Access Compliance Report

Public Rights-of-Way

(Curb Ramps)

Intersection ID: 46807	Main Street: ADLIN_AV	Cross Street: SWEET_BING_CT	Location: S
ADA ID: 328F02B7A57F	Ramp Type: Perp	Initial Pass/Fail: Pass	Overall Compliance: No
Severity Score: 17.5			
Codes/Mitigation Info/Possible Solution		Field Measurements/Component Compliance

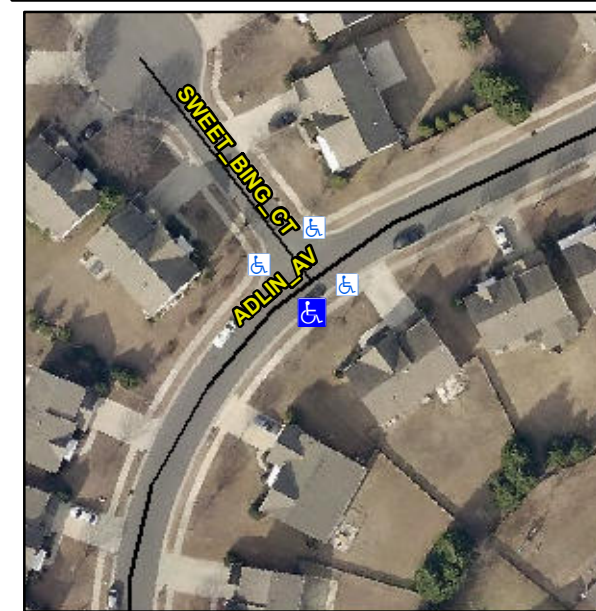
Not Found, R305, R302.7.2

Compliance	Description	Data	Compliance	Description	Data
N/A	Ramp Length (in)	47.0	Yes	Ramp Slope (%)	7.9
Yes	Ramp Width (in)	54.0	Yes	Ramp XSlope (%)	1.1
N/A	Flare Type LT	Sloped	N/A	Flare Type RT	N/A
N/A	Flare Slope LT (%)	6.4	Yes	Flare Slope RT (%)	7.1
N/A	Flare Traversable LT?	Yes	N/A	Flare Traversable RT?	Yes
Yes	Landing Length (in)	48.0	No	DWS Provided?	No
Yes	Landing Width (in)	54.0	N/A	DWS Contrast?	No
Yes	Landing Slope (%)	1.1	N/A	DWS Length (in)	N/A
Yes	Landing X Slope (%)	0.4	N/A	DWS Full Width?	No
N/A	Landing Curb? (Y/N)	No	N/A	DWS Offset (in)	N/A
N/A	Shared Landing?	No			
Yes	Gutter Ponding?	No	Yes	Gutter Slope (%)	1.8
No	Gutter Lip Ht (in)	0.5	Yes	Gutter X Slope (%)	0.1
N/A	Painted X Walk1?	No	N/A	Painted X Walk2?	N/A
	X Walk 1 Direction	To NW		X Walk 2 Direction	N/A
N/A	X Walk 1 Width (in)	N/A	N/A	X Walk 2 Width (in)	N/A
	X Walk 1 Slope (%)	3.7		X Walk 2 Slope (%)	N/A
	X Walk 1 X Slope (%)	0.3		X Walk 2 X Slope (%)	N/A

N/A	Ramp inside XWalk1?	N/A	N/A	Ramp inside XWalk2?	N/A
	Road Slope (%)	N/A	N/A	Clear Space?	Yes
	Road X Slope (%)	N/A	N/A	Clear Space to XWalk (in)	N/A
Yes	Any Obstructions?	No	Yes	Storm Grate/Utility Hazard?	No
	Obstruction Type			Storm Grate/Utility Type	
		N/A			N/A
			Yes	Surface Condition? (G/P)	Good

Remove & Replace Entire Ramp.
